Concept Knitting.(Extension)

Tilargati, Sataish Bazar, Tongi, Gazipur

12 February 2024

Typical floor loading

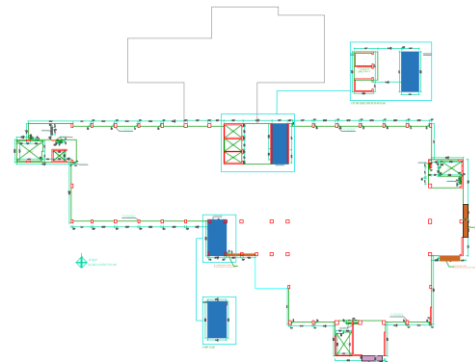
Observation-1: Stress in the column above normal design limit (New Garments Building).

Description: The cursory calculation indicates that the column is stressed above the normal design limit at the marked location considering the floor live load as per the provided load plan (6 kPa for the typical floor and roof). We have considered minimum concrete strength based on aggregate type due to inadequate number of concrete cylinder test reports and rebar strength 500 MPa from the available rebar test report. The building engineer is required to review design and column stresses based on in-situ concrete strength at the marked location. Also, produce and actively manage load management plans.
